## **Appendix 1 – Planning Application 23/02838/FP**

### **Pirton Parish Council comments**

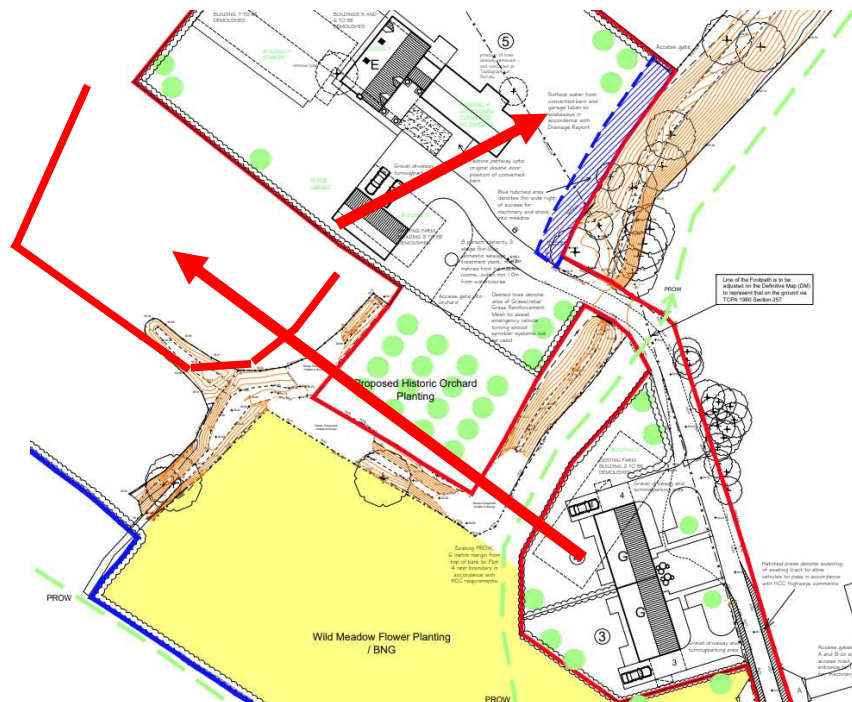
4.2 Looking at Plots 1 & 2 first, whilst I note this is the site of the existing later-built farmhouse and whilst the existing dwelling has a neutral impact upon the character and appearance of the area, I am unconvinced that replacing this building with two albeit, in my opinion, better designed dwellings is entirely appropriate here. The doubling up of driveway access points, garaging and bin storage etc and reduced rear garden curtilages is such that this has a significant impact upon the character of the site. Considering the Inspector's comment that the previously proposed three dwellings would "erode the spacious qualities of the plot, which contributes positively to the transition to the open and undeveloped backdrop of the houses within the PCA and the rural setting of the village", I am minded to suggest the following:

- Seek to retain a more spacious character by changing from the 2 x 3-bed proposal to perhaps a 1 x 4-bed with double garage parking i.e. a better singular designed version of what exists.

4.3 The above would also maintain the narrative of a 'farmhouse' rather than 'farmhouses' at the gateway to this former agrarian site.

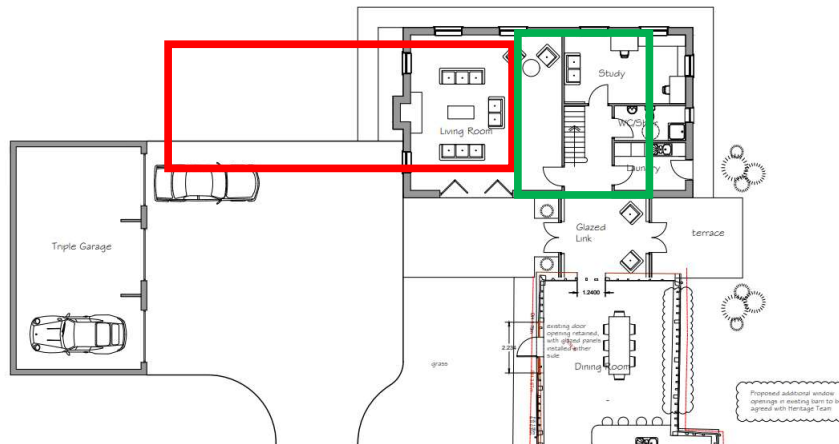
- 4.6 With respect to Plot 5, whilst there are occasions in the district where a barn is attached or linked to the house i.e., at Thistley Farm, Gosmore and Lower Green Farm, Ickleford, this is not the norm. Generally, agrarian buildings are either purposefully built i.e., Model Farm layout or are clustered together through time and use. The current site is neither of these. Considering the Inspector's remarks in respect of a smaller building to the south which would respect the barn's significance on the site, it would not seem right to entertain a two-storey overtly domestic building appearing alongside the barn as indicated below. In my opinion, this approach is fundamentally flawed.

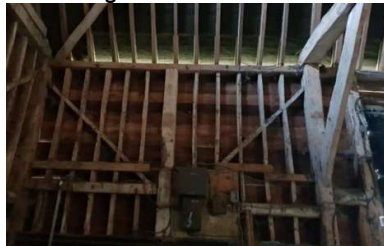
- 4.12 It is unclear from the submission as to what effect the 10no. new glazed openings in the walls would have on the existing frame. For instance, to the two smaller windows on the front elevation would appear to interfere with the either studwork, diagonal braces or the larger horizontal sections of framing in the image below (photo 15 of the Structural Condition Report). This should be established before proceeding further and the following is noted at 4.2.6 of the aforementioned report:

*Where additional openings are proposed, either to the gable or within the wall structure, further strengthening would likely be required to the timber frame by doubling up of studs and rafters, for example. Sufficiently sized headers should be provided, supported off these doubled up members to provide a lintel detail. This detail would need to be confirmed by Structural Engineer's calculations. Any large openings will require checking to ascertain the panel is still sufficient to prevent racking.*

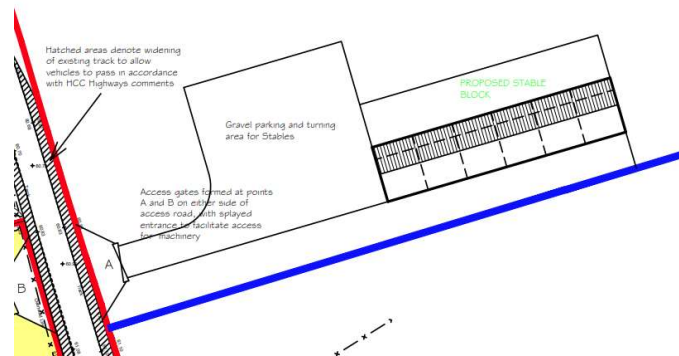
- 4.13 I am also unconvinced that the intrusions are kept to the minimum considering that there would be 6no. new openings in the rear wall and 4no. new openings in the front wall (if counting the glazing either side of the existing personnel door). I am not convinced that the dining room need be served by 6no. openings and for this reason I suggest that glazing could perhaps be inserted where the small door opening is on the front elevation and the door retained in an open position (like a shutter). Similarly retaining larger barn doors in a pinned back 'open' position serving the larger glazed opening would be sympathetic to the barn's agrarian character and would probably require the proposed left-hand smaller window in the front elevation to be omitted.
